SAFETY EVALUATION BY THE OFFICE OF NUCLEAR REACTOR REGULATION
OF THE THERMAL SHIELD SUPPORT SYSTEM REPLACEMENT DESIGN
FOR SAN ONOFRE NUCLEAR GENERATING STATION, UNIT NO. 1
RELATED TO AMENDMENT NO. 140 TO PROVISIONAL OPERATING LICENSE NO. DPR-13
SOUTHERN CALIFORNIA EDISON COMPANY
SAN DIEGO GAS AND ELECTRIC COMPANY
DOCKET NO. 50-206

December 1990

SAFETY EVALUATION
OF THE THERMAL SHIELD SUPPORT SYSTEM
REPLACEMENT DESIGN
FOR SAN ONOFRE NUCLEAR GENERATING STATION, UNIT NO. 1
DOCKET NO. 50-206

ISOMETRIC VIEW - CORE BARREL & THERMAL SHIELD

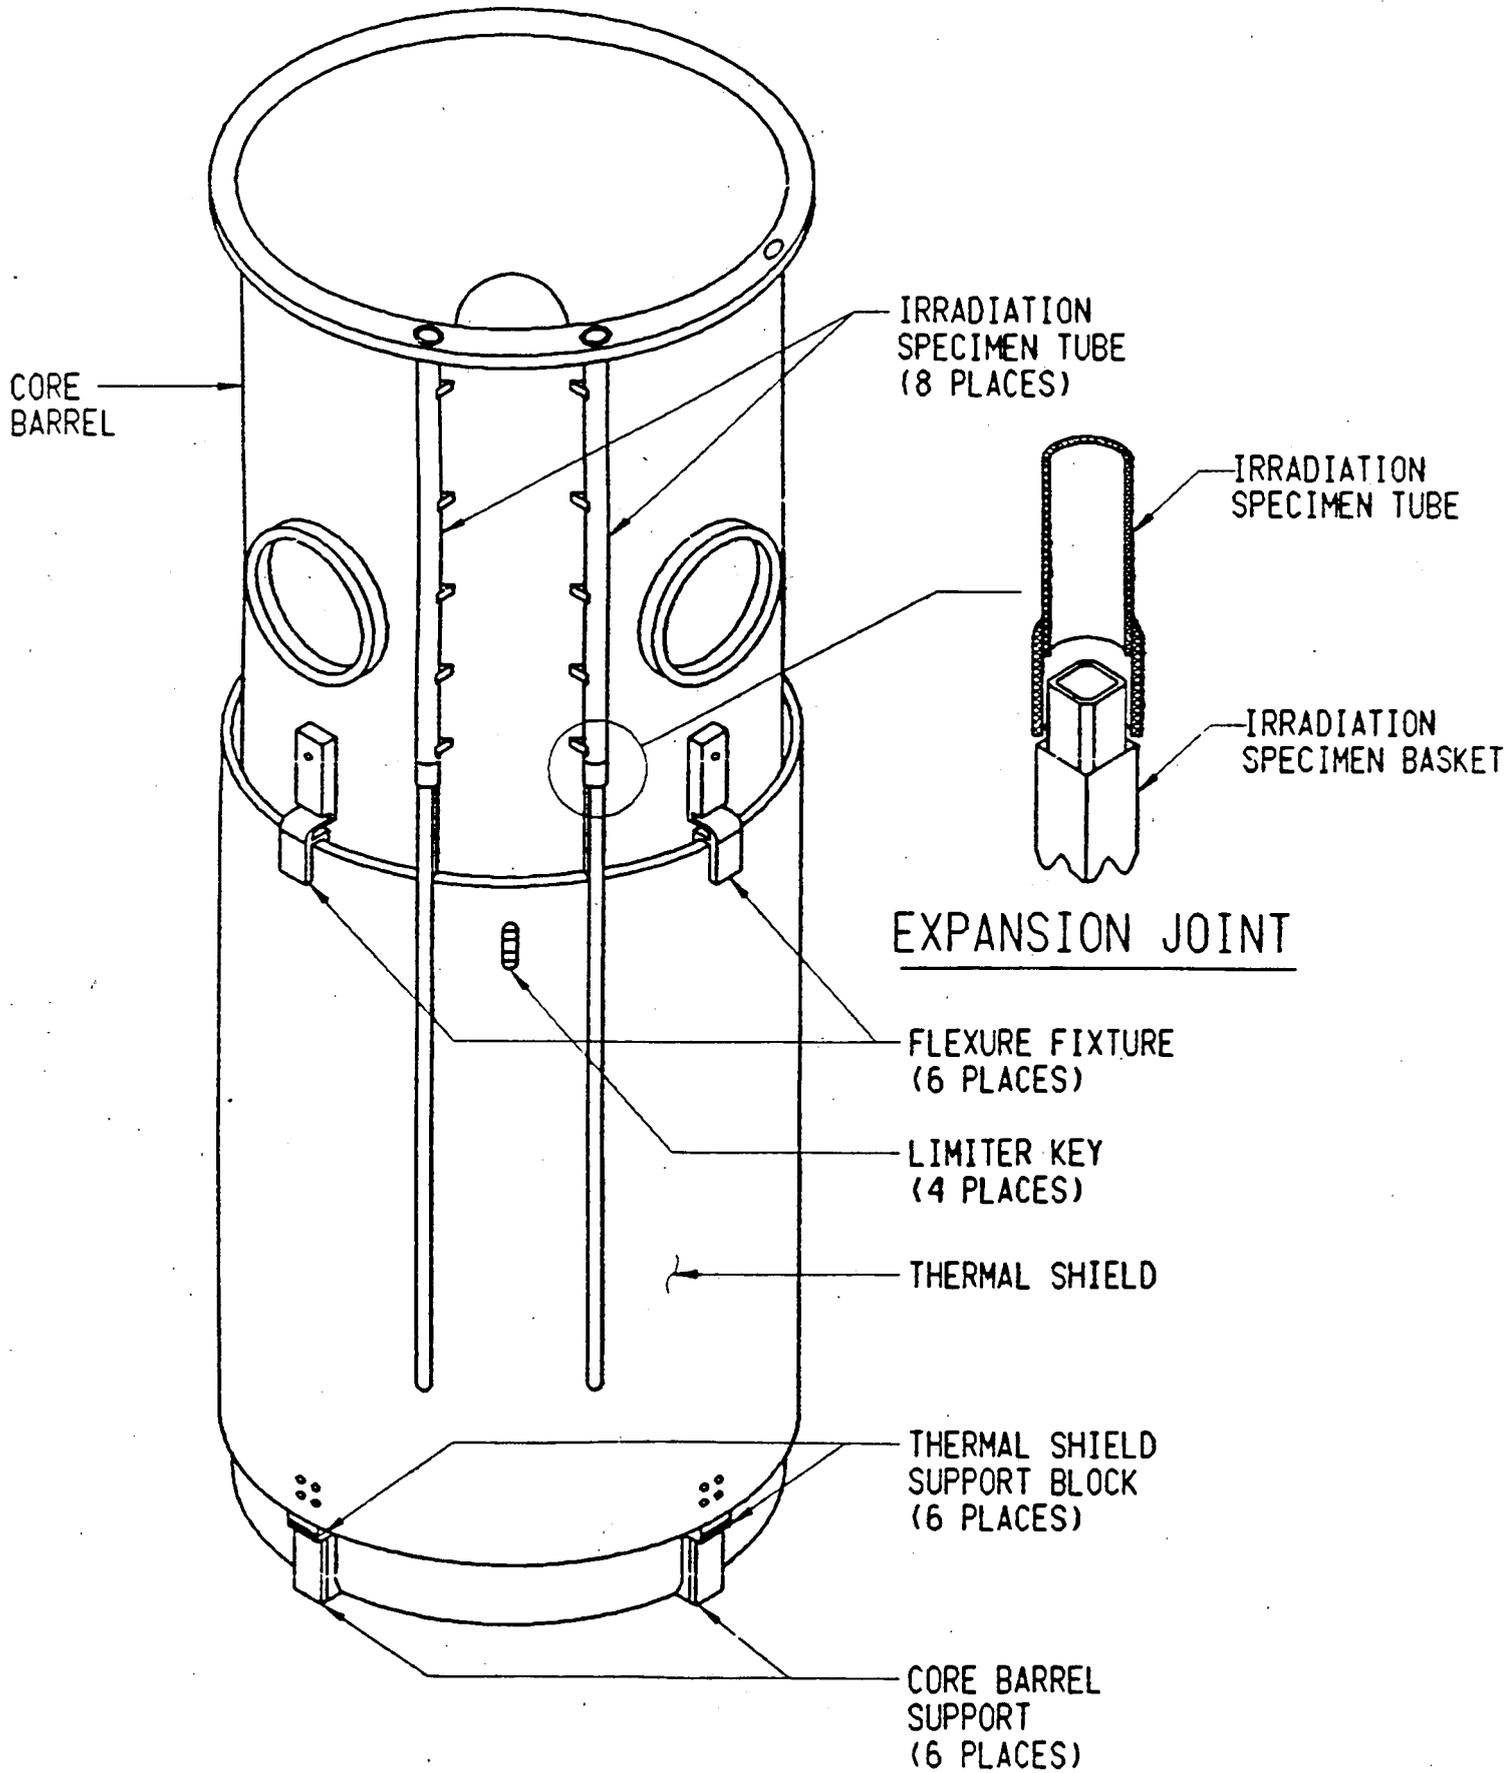
The thermal shield support systems in the SONGS-1 and Haddam Neck plants are of similar design (See Figure 1). In this design, the thermal shield is supported by the reactor core barrel. Components of the support system are: (1) six "flexure" supports attached to the upper edge of the thermal shield, (2) four displacement limiter keys near the upper edge of the thermal shield, and (3) six support blocks attached to the lower edge of the thermal shield. Although of similar design, due to the difference in plant sizes, there are differences in the size and location of the support system components used in the SONGS-1 versus the Haddam Neck plant as well as in the number, size, and location of the fasteners for the various components.
